MONTICELLO NUCLEAR GENERATING PLANT E-5979  
Docket No. 50-263  
CHANGE REQUEST NO. 3

REQUEST FOR AUTHORIZATION OF  
A CHANGE IN TECHNICAL SPECIFICATIONS  
OF APPENDIX A

(Change Request No. 3)

MONTICELLO NUCLEAR GENERATING PLANT  
DOCKET NO. 50-263PROPOSED CHANGES TO TECHNICAL SPECIFICATIONS  
APPENDIX A OF PROVISIONAL OPERATING  
LICENSE NO. DPR-22

3.9/4.9-4

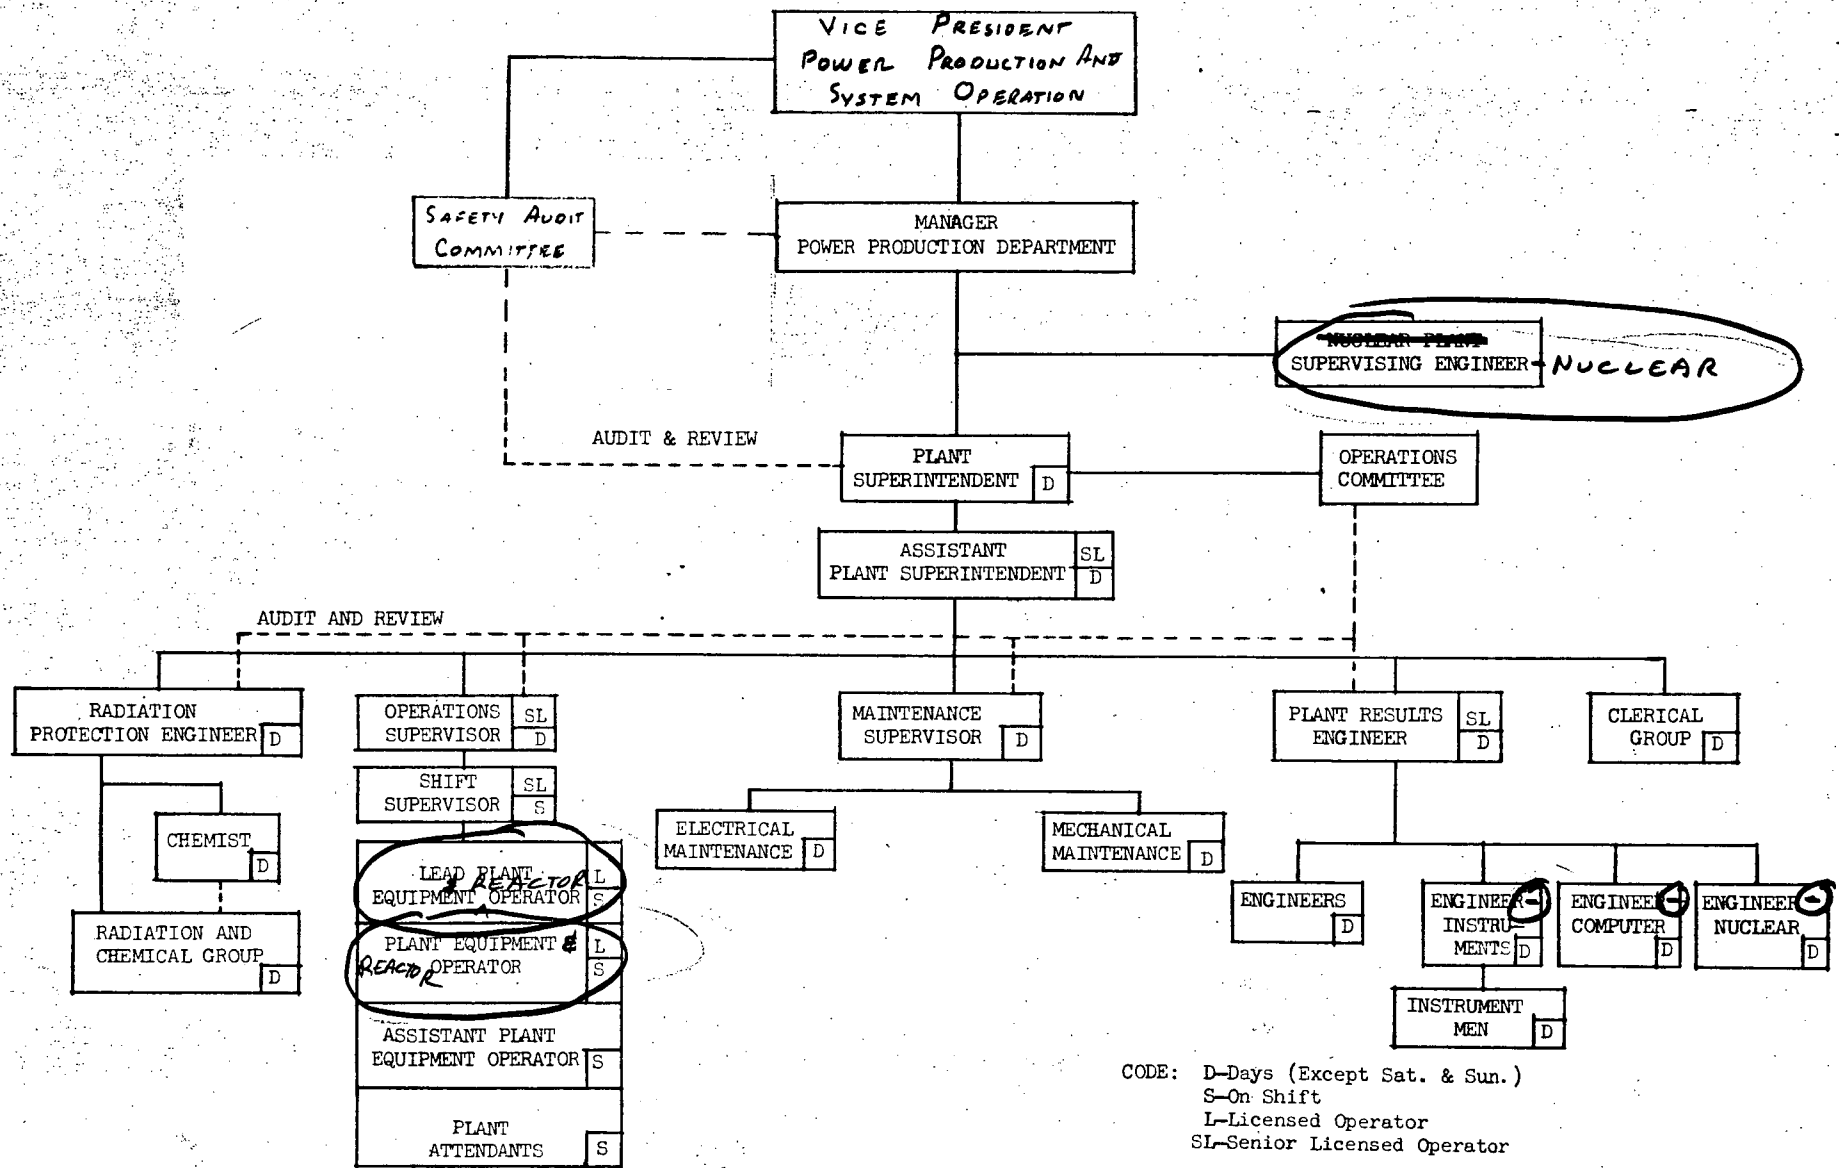
~~From and after the date that~~ <sup>if</sup> one of the two 125 V battery systems or the 250 V battery system is made or found to be inoperable for any reason, ~~reactor operation is permissible only during the succeeding 72 hours unless such battery systems are sooner made operable.~~

*an orderly shutdown of the reactor will be initiated and the reactor water temperature shall be reduced to less than 212°F within 24 hours unless such battery systems are sooner made operable.*

24. Page 183, Item 3.9.B.4  
Change to read as follows:

If one of the two 125 V battery systems or the 250 V battery system is made or found to be inoperable for any reason, an orderly shutdown of the reactor will be initiated and the reactor water temperature shall be reduced to less than 212°F within 24 hours unless such battery systems are sooner made operable.

The proposed change is more restrictive than existing requirements but is more consistent with intended operation.

FIGURE 3.4.1. Sodium Pentaborate Solution Volume  
— Concentration Requirements

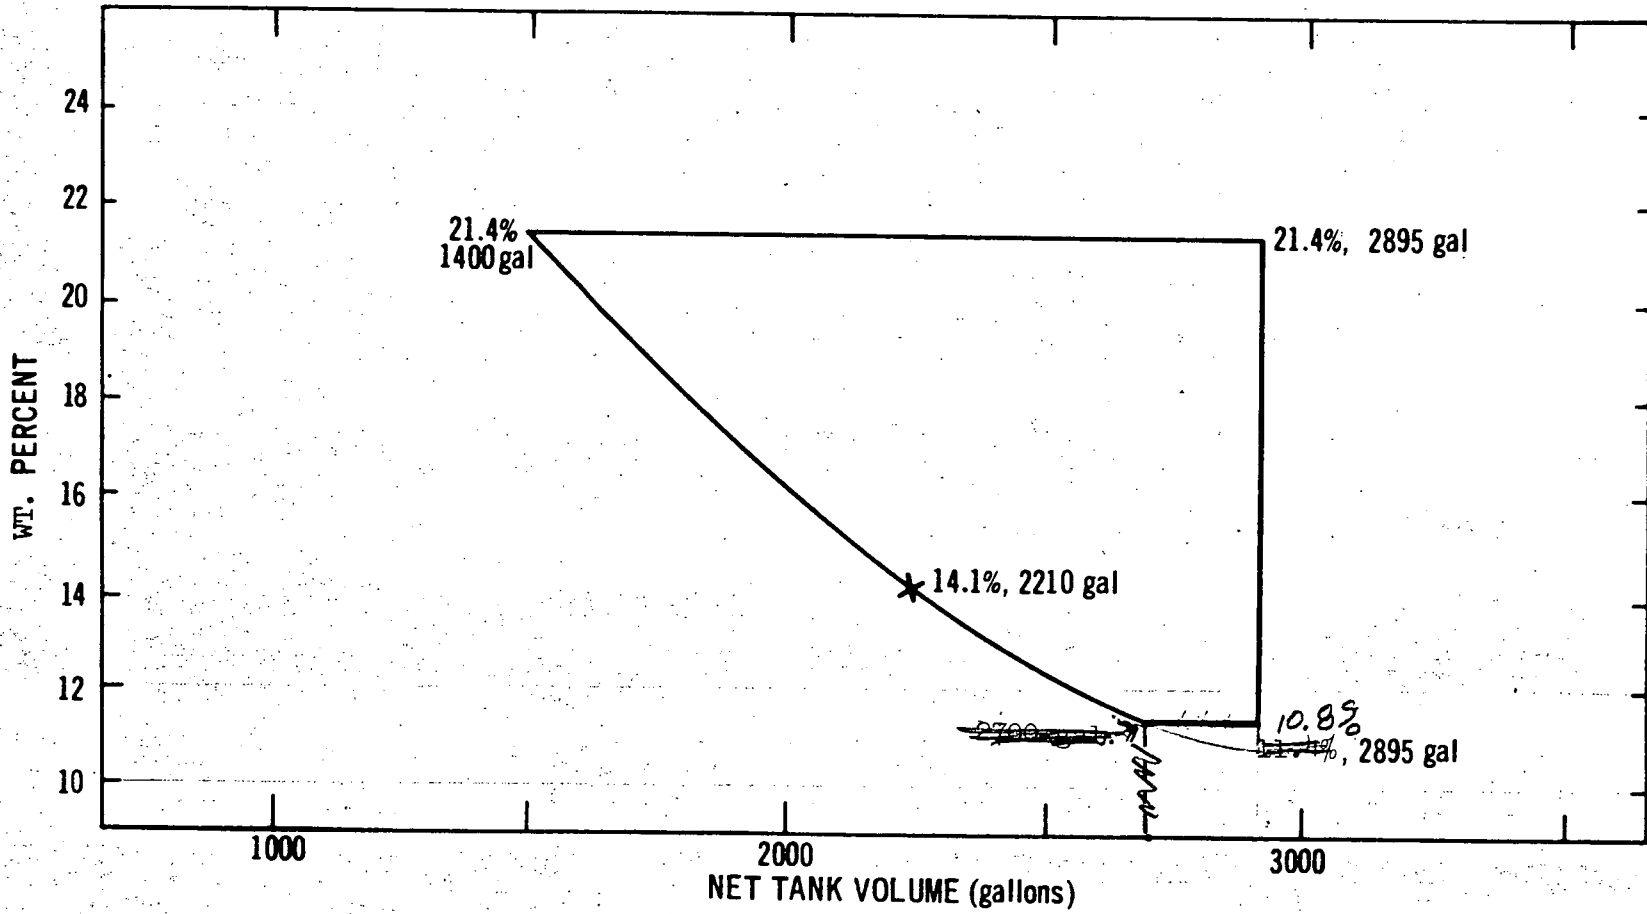
12. Page 92, Figure 3.4.1

Continue lower portion of curve to terminate at 10.8% at 2895 gallons. Remove limit of 11.4% at  $\geq$  2700 gallons.

In one of the early draft versions of the Technical Specifications the bottom portion of the curve was removed to assure that the required amount of boron would be injected within 100 minutes at a minimum flow of 27 gpm. Subsequently, the requirements were changed. The present specification and bases require a minimum flow of 24 gpm and a pumping time not to exceed 125 minutes. Restoration of the lower portion of the curve is consistent with the present bases and will allow lower concentrations, thereby reducing minimum temperature requirements and reducing the possibility of crystallization.

FIGURE 2.1.1 FUEL CLADDING INTEGRITY SAFETY LIMIT

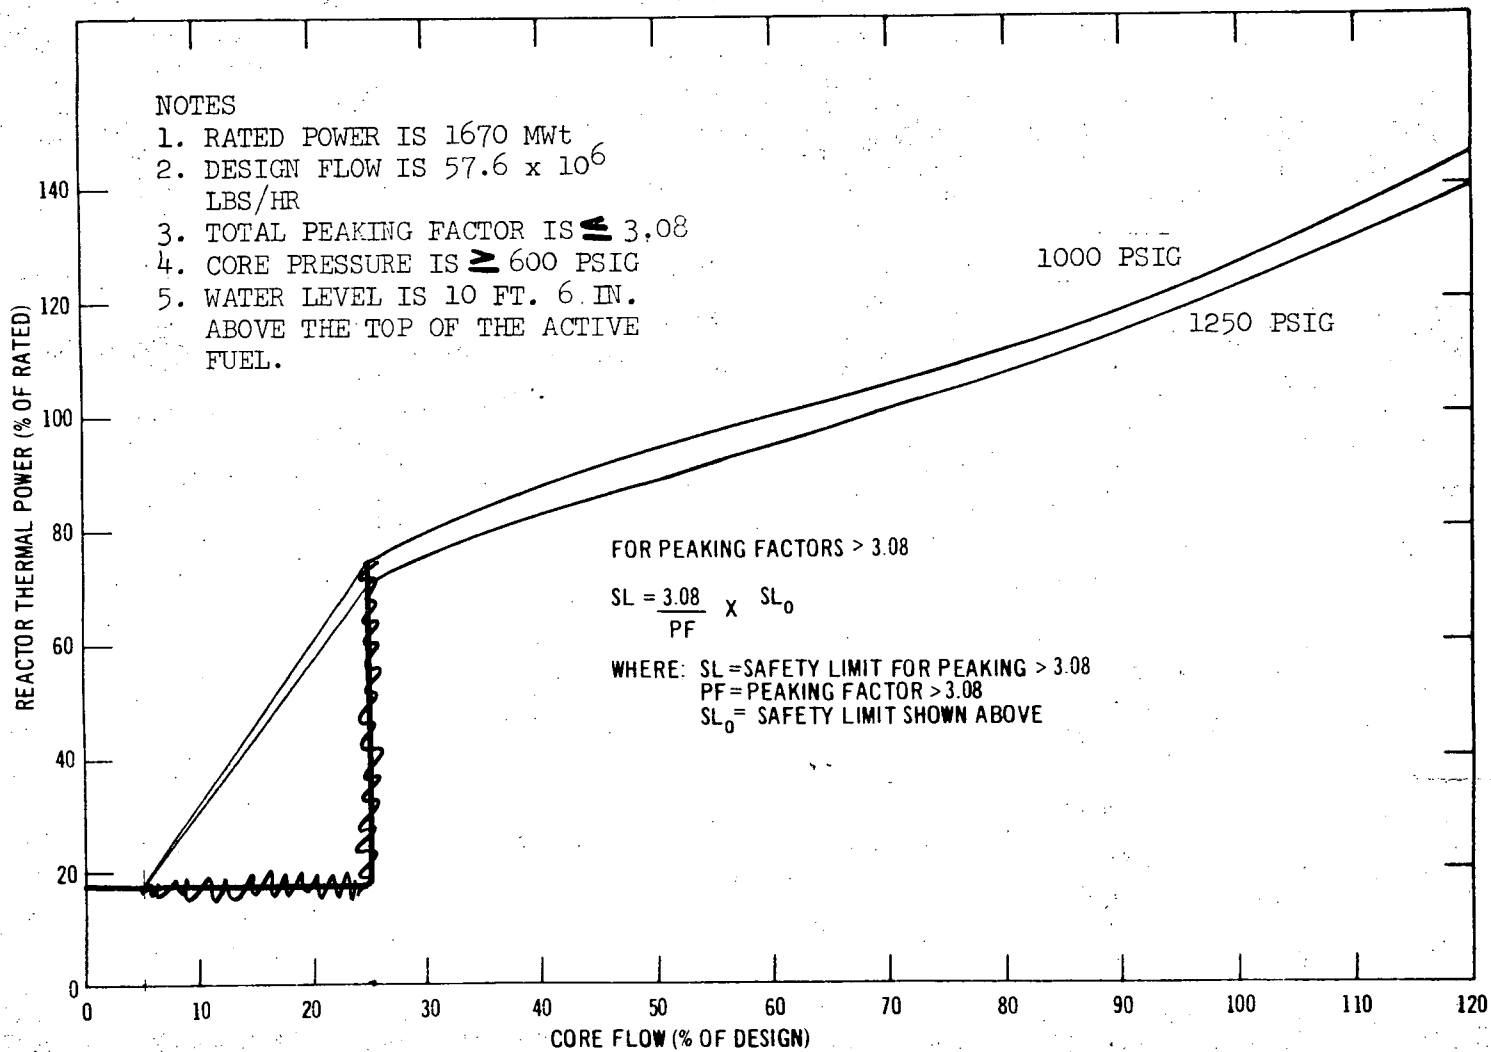
Page 10, Figure 2.1.1

Extend the two curves linearly from the present termination at 25% to 5% at 18% thermal power (300 MW).

The basis given for fuel cladding integrity safety limits applies to the lower core flow limit of 5% but with less margin than the current lower limit of 25% flow. Following recirculation pump trip test at Monticello, the operating point was found to be close to the 25% flow limit line. The change will decrease the chance of a "technical" violation of the specification and will make the safety limit curve consistent with curves presently in use at other facilities.
